Letter to Wilton Zoning Board

4/9/24-1 (Wilders)

Source: NRPC with wetland overlay / NH Granit with NWI Plus

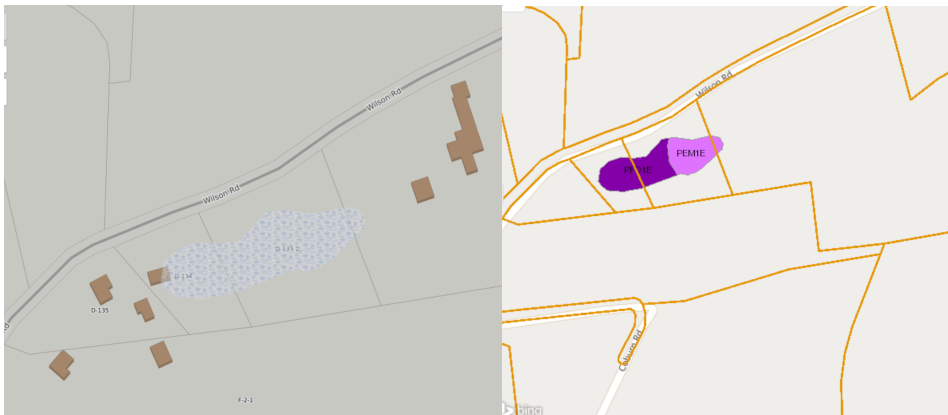
The Wilton conservation commission recommends a site walk in association with this case. Review of available wetland mapping shows the NWI overlay having a mismatch between plan mapping and the NWI. Although the NWI can have variances this should be reviewed in the field. The Wilton Conservation Commissions position would be to minimize impact to the wetland resource on site as much as possible. This was originally reviewed due to the west portion of the lot having a non-wetland section according to the plan. Although it may be within a lot line setback it could minimize wetland impact as an alternative. Septic field setbacks should also be reviewed. Wilton has a stricter standard in some circumstances depending on drainage.
